INTERNATIONAL 420 CLASS ASSOCIATION

**GENERAL ASSEMBLY
Travemünde - 2014**

PROPOSAL FOR CLASS RULES CHANGES

INTERNATIONAL 420 CLASS RULES

C.8.3 RUDDER

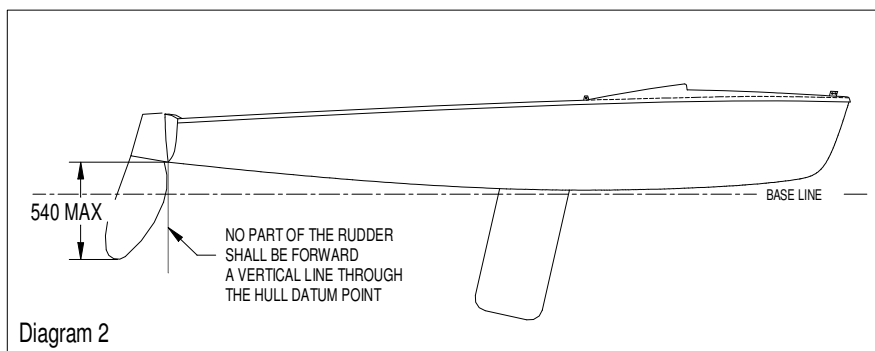
C.8.3(a) The rudder blade shall be in its fully lowered position.

Reason: The rudder blade is meant to be used in this position.

Comment [DD10]: New rule

The rudder blade shall be in its fully lowered position.

No part of the **rudder** blade, when fully lowered, shall extend more than 540 mm below the HDP. The leading edge of the **rudder** blade shall not be forward of a vertical line through the HDP (see measurement diagram 2).

DIAGRAM 3

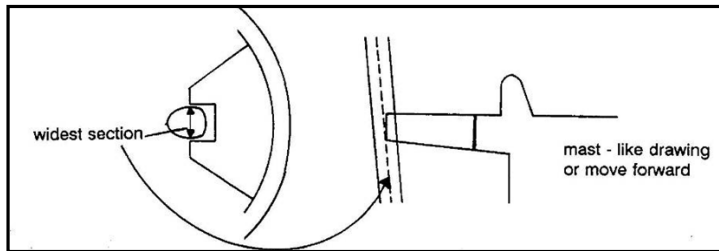
Reason: This is a major change in the way the boat is sailed, making it easier to adjust fore & aft bend but only locally. In addition, provision is made for a safety arrangement to prevent mast inversion when the mast partner is not closed on the aft end and chocks cannot be used for that purpose.

Comment [DD11]: This is a major change in the way the boat is sailed, making it easier to adjust the bend but only locally. In addition, provision is made for a safety arrangement to prevent mast inversion when the mast partner is not closed

1) ~~Chocks may be used to control the~~ The fore and aft bend of the **mast spar** at the mast partner level may be limited either by chocks or by an optional system of single piece of rope, one attachment, one grip and one cleat without moving parts, on top of the mast partner. ~~Chocks or an additional system of single piece of rope, one attachment, one grip and one cleat without moving parts on top of the mast partner may be used to induce bend to the mast or to keep it from inverting.~~

With the mast spar in its most forward position, the grip or end of rope of the aft bend control shall not be more than 150mm from the mast partner. With the mast in its aft most position the grip of the forward bend control shall not be more than 150mm from the mast partner.

Diagram 12

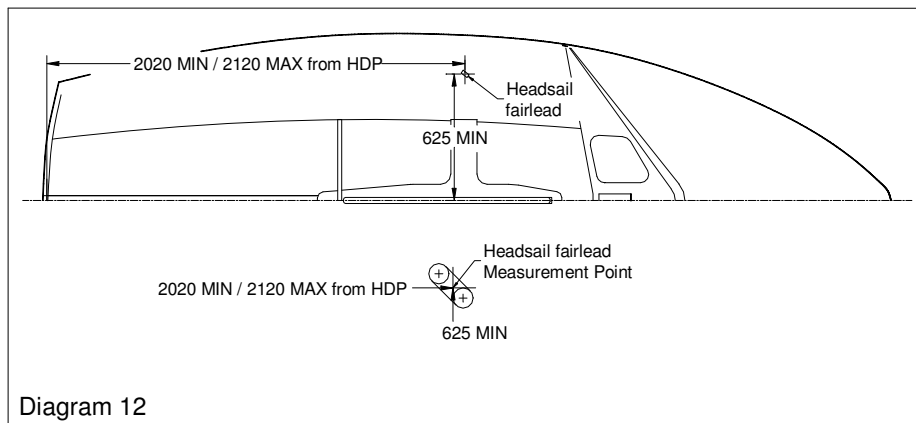
D.4.2.1 (e) Two headsail fairleads, the measurement point of which shall be at 2020 mm minimum and 2120 mm maximum from the HDP and 575 mm minimum from the centreline. The fairleads shall be fixed directly to the buoyancy tanks (see diagram 12).

Reason: The current position of the jib sheet fairleads (625mm) is too far outboard, requiring windward sheeting in many conditions. Moving the fairleads inboard can reduce the need for windward sheeting and may help sailmakers design more efficient jibs. The exact position will be determined by further testing, and the aim is to use the position that is currently taken by the jib sheet cleats. The cleats may be positioned further inboard with the help of a wedge, a rounded bracket or even a small modification in the deck moulding. In this way, existing boats can have the fairleads in the new position without serious modifications. This rule, if approved, will be in effect from 2015 to allow time for the modifications in the boats, and the new jib designs.

Comment [DD15]: 1250mm minimum distance from one port side fairlead to the starboard side fairlead.

The distance may be reduced to 1150mm or less, so that windward sheeting is not needed as it is today.

Exact value to be confirmed following tests.
